## Circuit Analysis Report

Test IC	AT86RF212	
Crystal	Holder	NX3225SA
	Frequency	16.000MHz
	Load capacitance	CL=8pF[IEC] (Current) <b>CL=10pF[IEC] (Suggested)</b>
	NDK Spec. No.	STD-CSR-6(J) (*J:CL=10pF[IEC])
Test Circuit	IC	ATRF212 58902-01 1018 PH 8S5817-9
	VDD	+3V / +1.8V
	PCB	TB2_XMEGA_212 AVR2067 - Crystal Characterization for AVR RF

### 2. CIRCUIT DIAGRAM

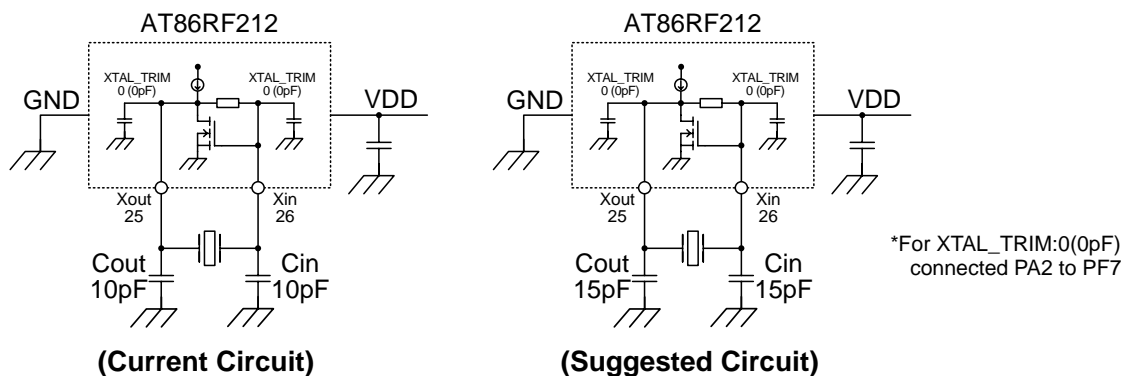
- 1) This crystal unit requires negative resistance of  $-R = 800\Omega$  minimum for stable oscillation
- 2) Circuit characteristics

- 3) Although the negative resistance of the current circuit is over our target, it seems too large.
- 4) In order to improve negative resistance, we recommend changing external capacitance values from Cout/Cin=10pF/10F to **Cout/Cin=15pF/15pF**. Besides, we recommend changing crystal load capacitance value from CL=8pF to **CL=10pF** in order to improve frequency deviation.

Circuit	Cout/Cin	XTAL_TRIM (Internal Cap)	Frequency deviation dF/F	Negative Resistance -R	Drive Level DL	Startup time Tstr
Current	10pF/10pF	0 (0pF)	+2ppm (CL=8pF[IEC])	3280 $\Omega$	Less than 10uW	1.5ms
Suggested	15pF/15pF	0 (0pF)	<b>-4ppm (CL=10pF[IEC])</b> Ref.: -29ppm (CL=8pF[IEC])	2030 $\Omega$	Less than 10uW	2ms
